RE: John Street Pond Feasibility Design Analysis Report
Engineer's Stamp Date: No Date
Hydrology File: L14D067

Based upon the information provided in your submittal received 10/13/2023, the Analysis Report **is not** approved. The following comments need to be addressed for approval of the above referenced project:

JOHN STREET POND FEASIBILITY DESIGN ANALYSIS REPORT

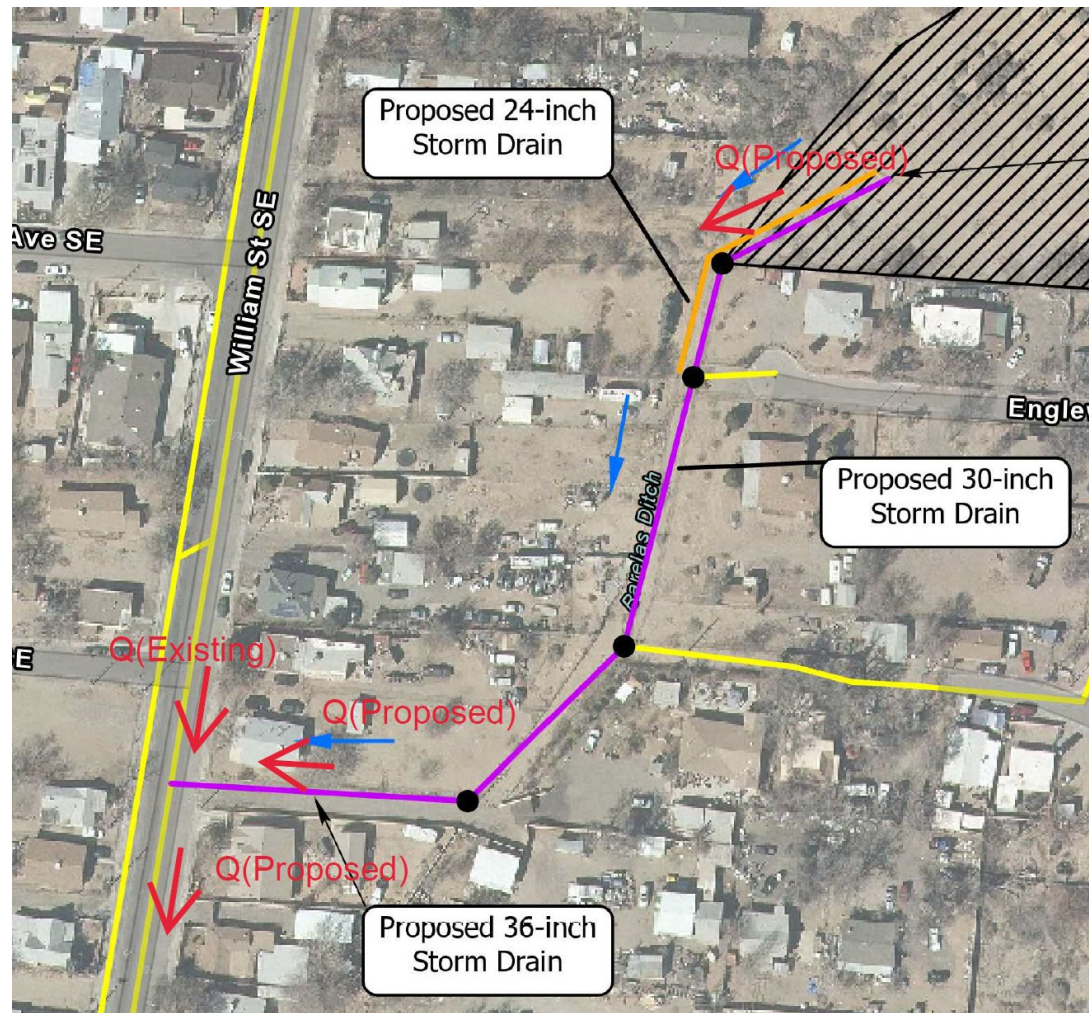
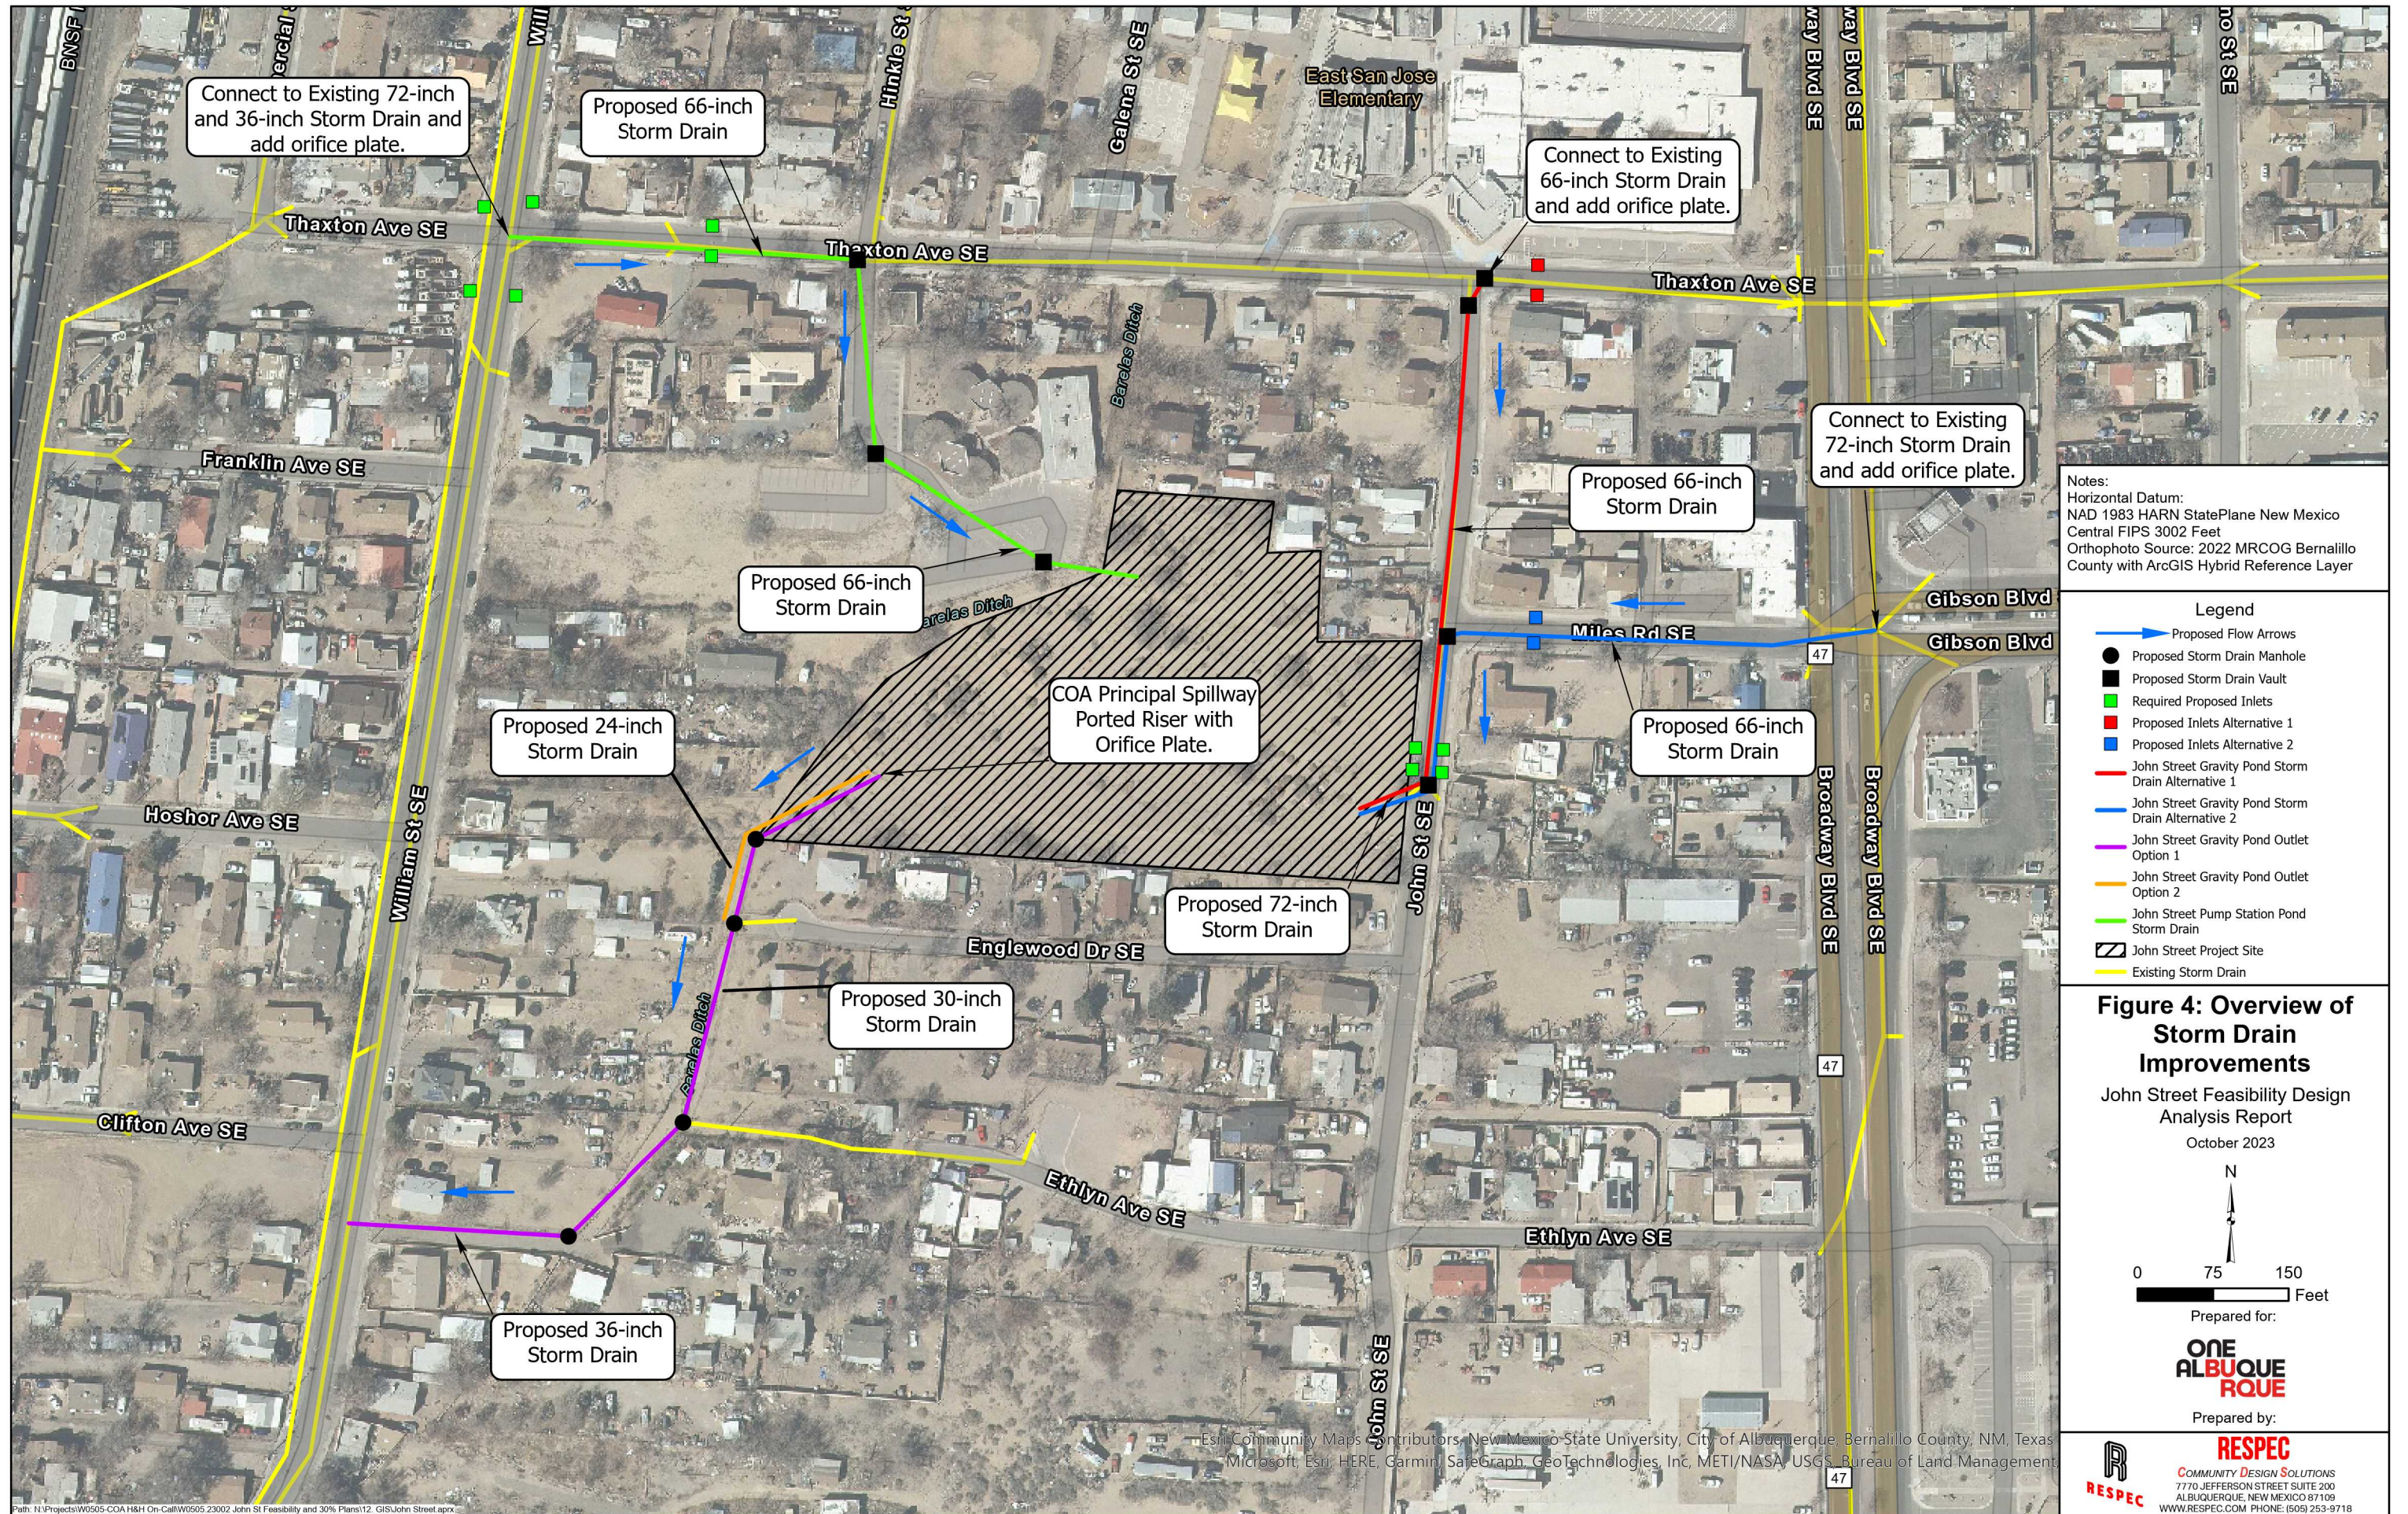
5. Figure 4, Overview of Storm Drain Improvements. It would be very helpful if you include the Q_{100} at the storm pipe for both the existing and the proposed on the map. (See below) This should help explain how the whole proposed system will help with the capacity in the existing storm drain by the proposed detention & pump station.

Figure 3: Proposed Subbasin Map
John Street Feasibility Design
Analysis Report

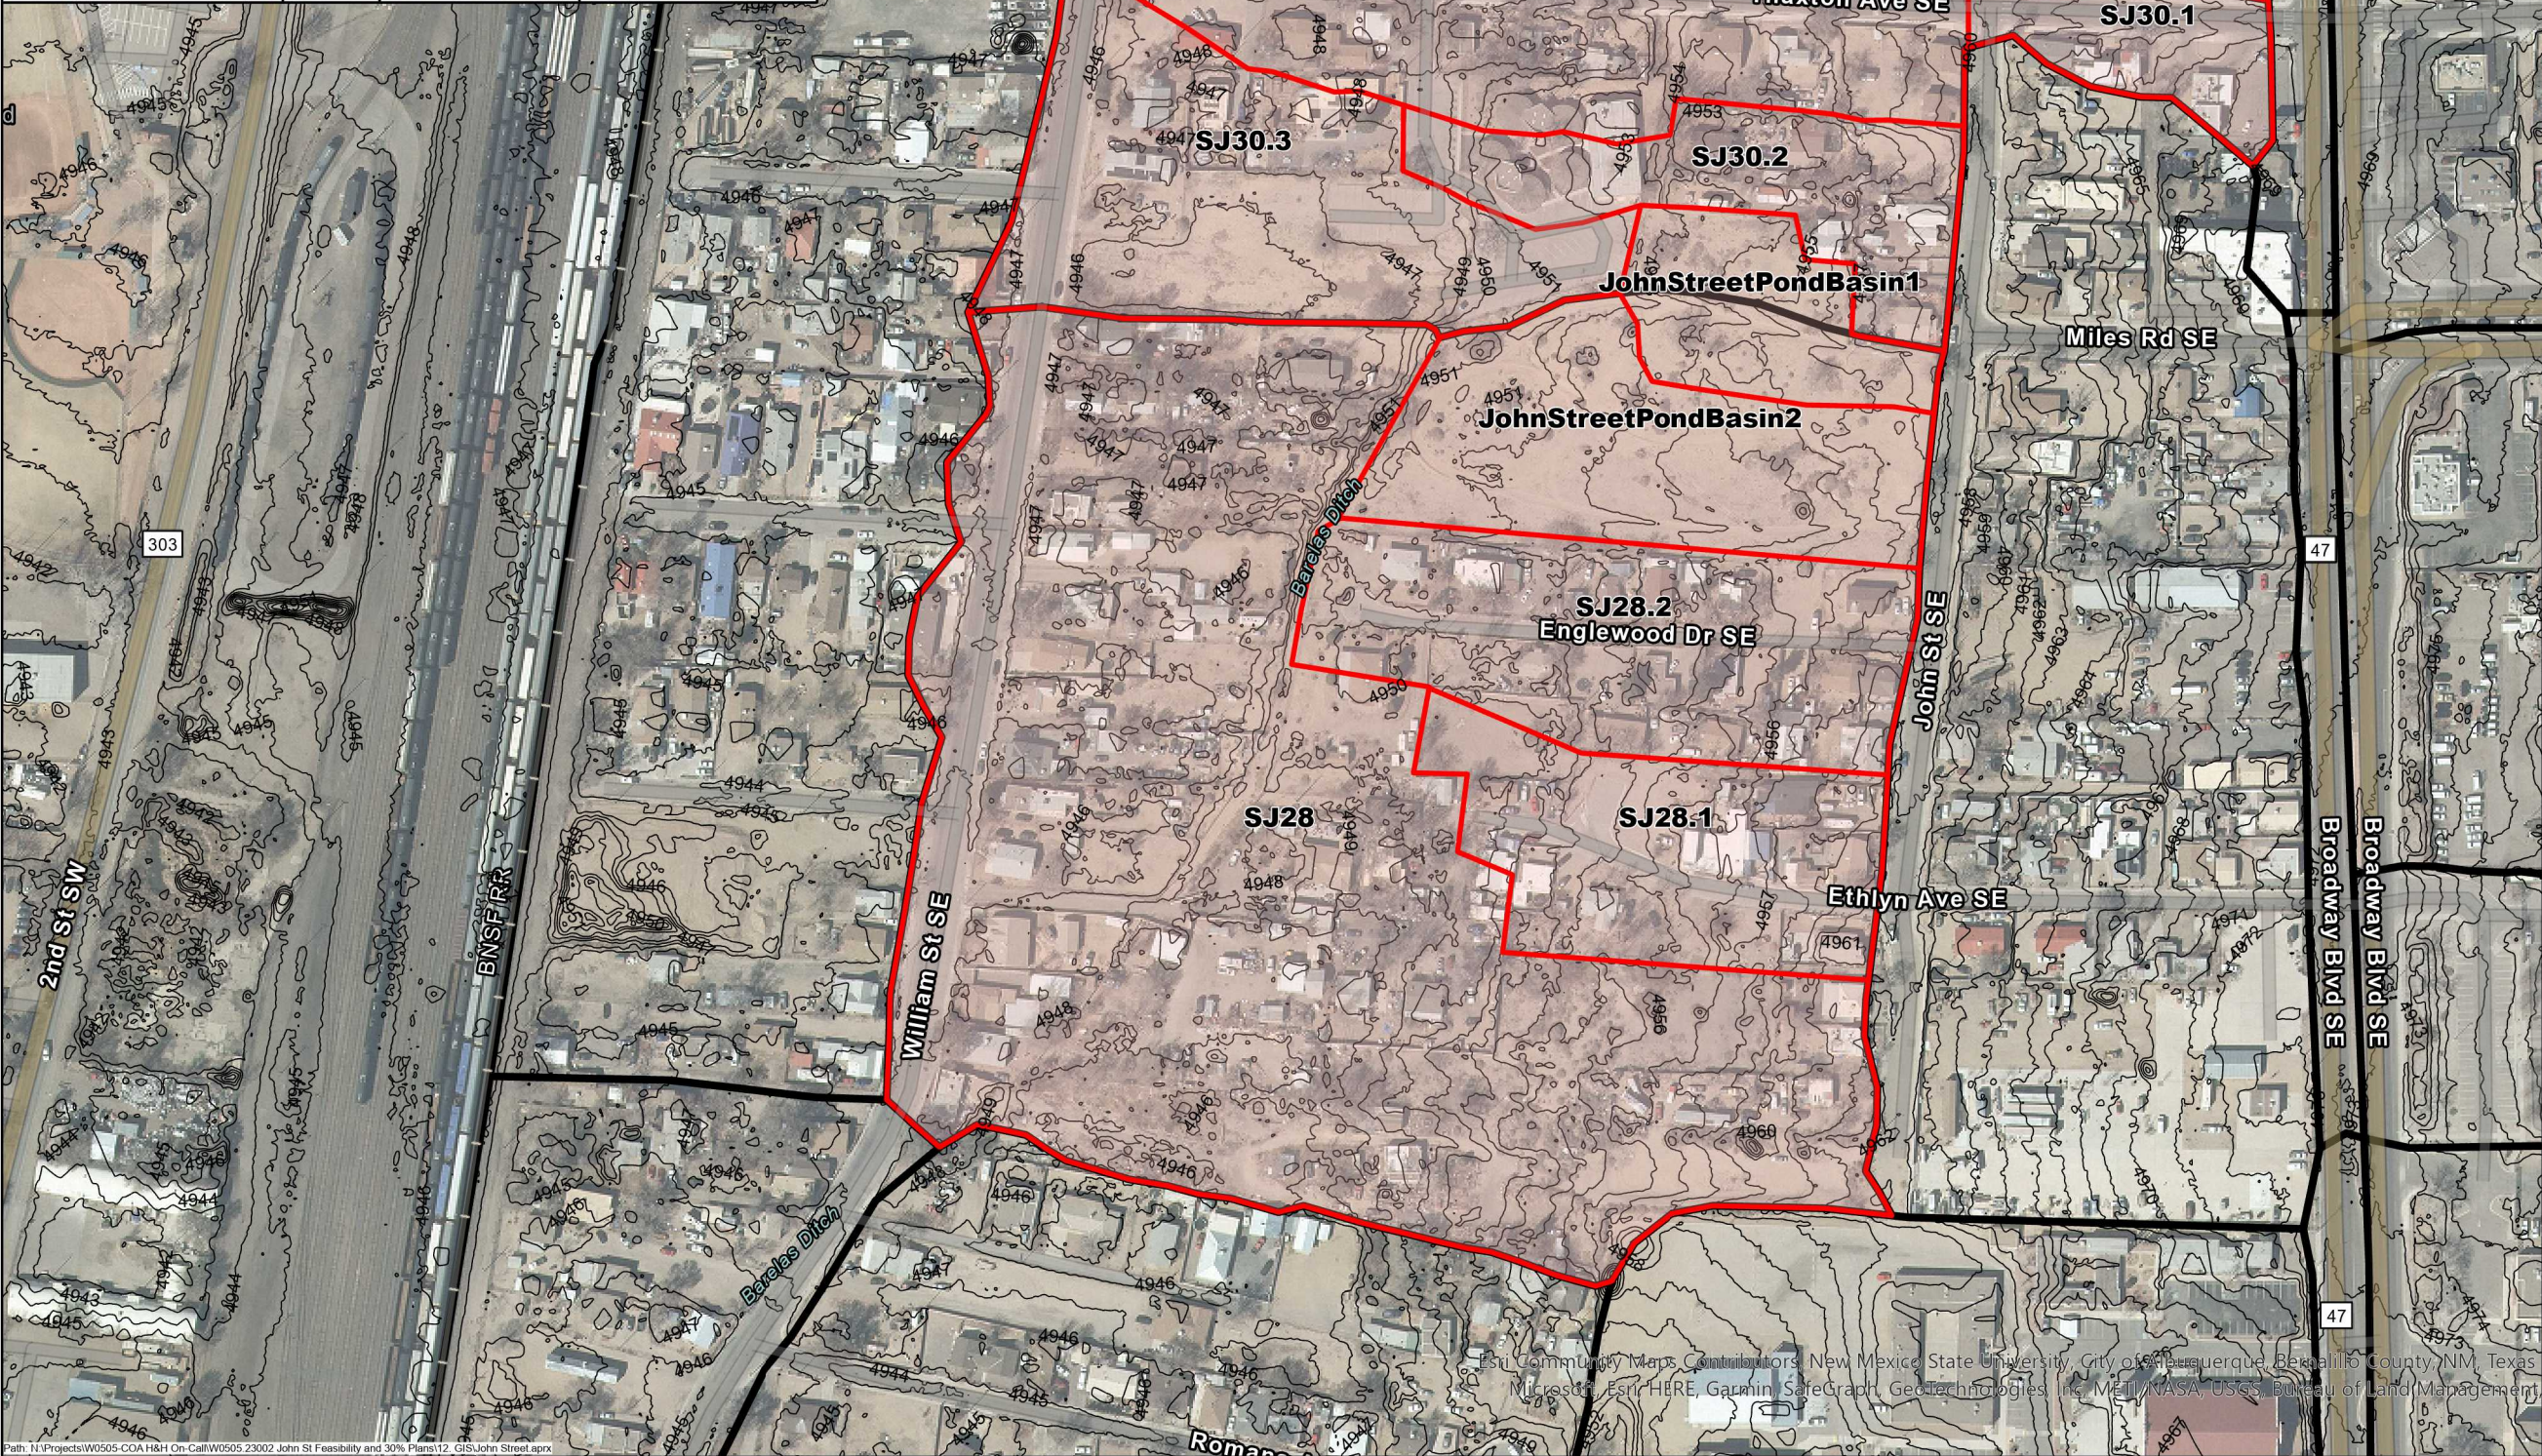
3. In 2.1 Existing Conditions, the section just refers to the updated SBDMP without a map. A map showing the existing subbasins similar to Figure 3 (Proposed Subbasin Map) would be helpful.
